# **SOUTHEASTERN UTAH DISTRICT HEALTH DEPARTMENT**

Your application for a septic tank installation to serve a bath house in Bear Canyon, Emery County has been received and is in the process of being reviewed. Before a final determination can be made additional information is needed. Those items needing clarification are as follows.

This letter is in regard to the Co-op Mine, Bear Canyon operation. I talked with you over the phone about two proposed septic tank systems. One is for a truck scale house and an office building, and the other for a proposed bath house.

# Proposed plan for Septic System for Bath House - Bear Canyon - Co-op Mining Co.

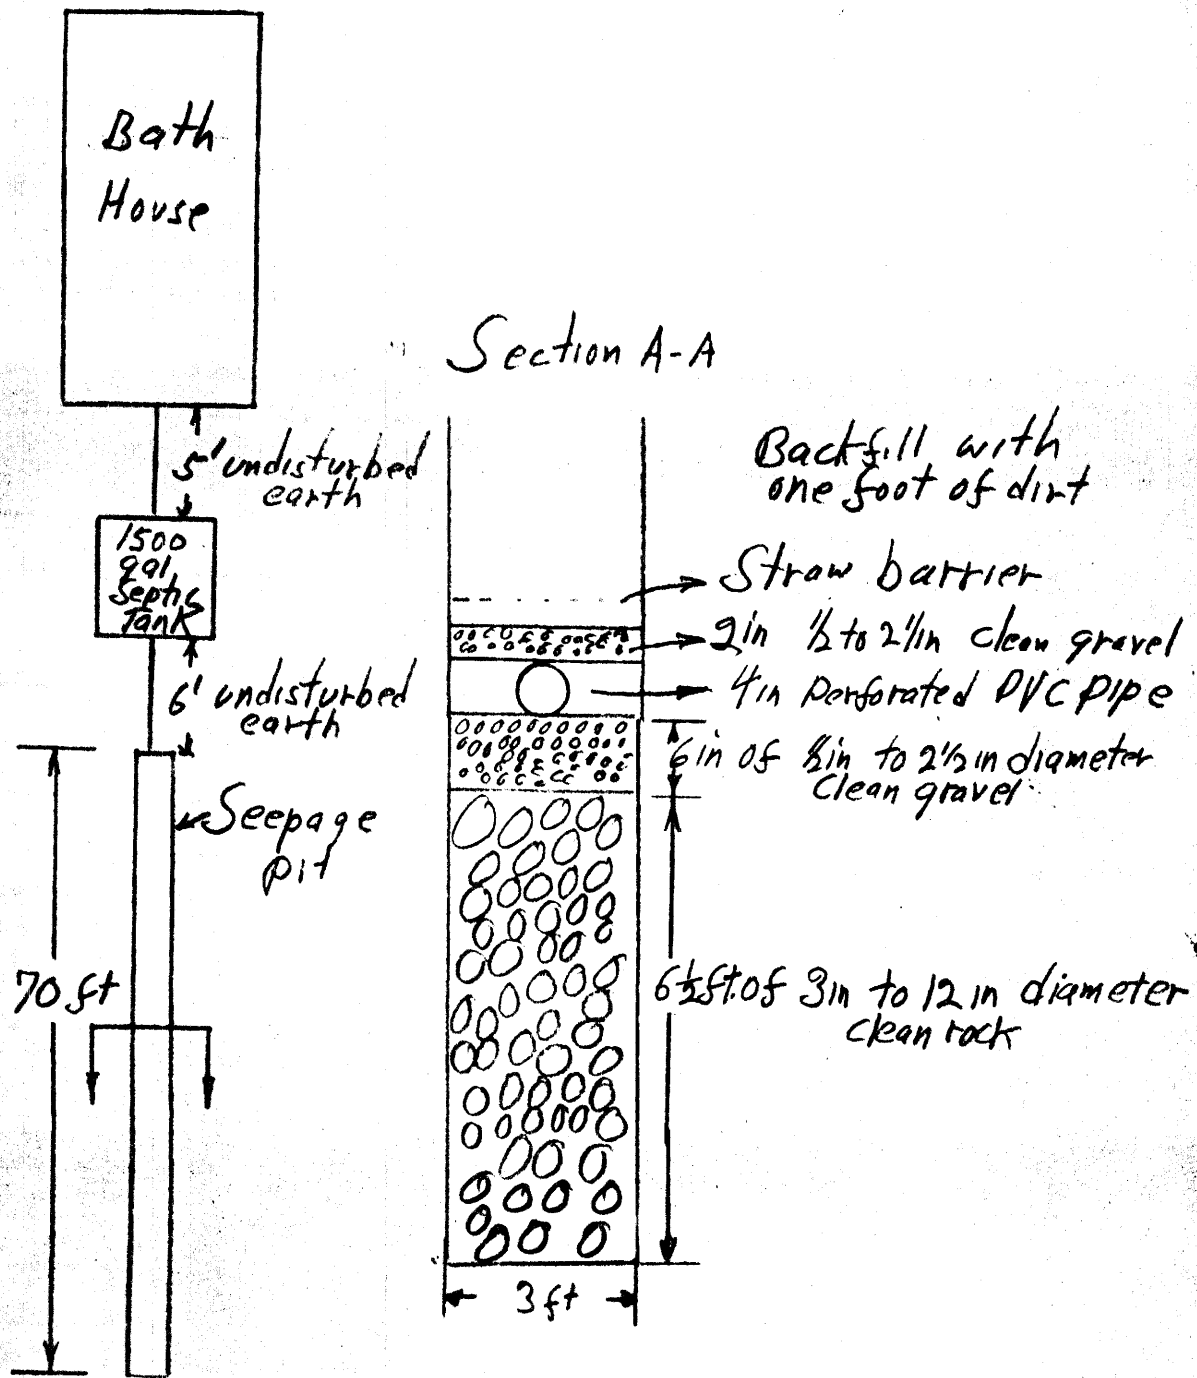
A contour map of the area of the drain field should be supplied. This should be at 2 foot intervals and show the location of any ditches, streams, or gullies in the area of the proposed drain field.

The test holes for soil conditions and water table should extend to a depth of at least 4 feet below the bottom of the proposed drain system. Evidence of suitable soil must be given for all parts of the system.
